BULLER RIVER

Update of Hydraulic Model

UPDATE OF HYDRAULIC MODEL

Review of Buller MIKE FLOOD model

Figure 2-2 Part of model topography

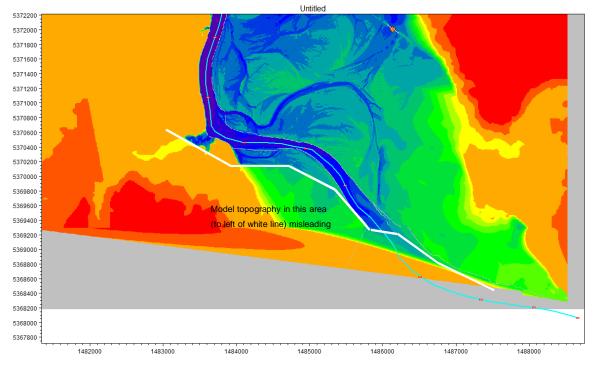
Parts of the upper areas of topography are misleading, a product of the interpolation process where no topography data exists. An example is in the area to the south and west of the white line in Figure 2-2. Although most of this area will not be flooded from the river, flood maps in the

August 2015 report do show some overflow into the left bank floodplain (in the green area identified as misleading in Figure 2-2). For that left bank pocket of floodplain, it is possible that the model topography overestimates actual ground levels, reducing the available floodplain storage in the model. Further effort in the defining the model topography in this area is recommended, if necessary by commissioning some site survey. In other areas where river flooding would not occur, it would be best to remove the misleading topography from the model.

The model topography for the left bank pocket of floodplain, before the river turns to the north, should be reassessed. That may require additional survey.

As extra survey information was not immediately available, this has not been included for now and it is recommended that flood extents are only presented for areas downstream from this location.

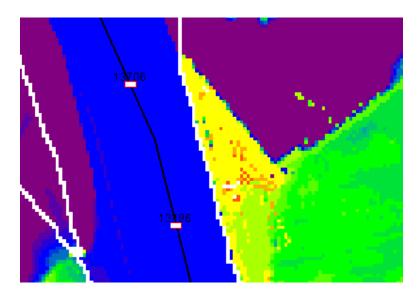
• Why does xs 4 not have a right bank up to/above the WL – see this plot: This has been rectified.

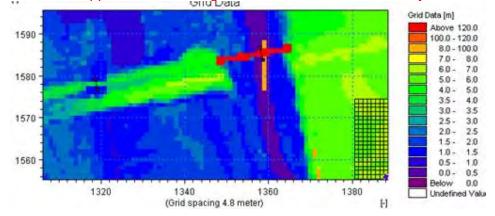
Topo – in the file I have, there is a short section either side of the Stephens Road Main Bridge that has high cells in the topo –presumably an error (but of no real consequence for results). See plot: This was supposed to be a negative value to match the survey I had...now rectified
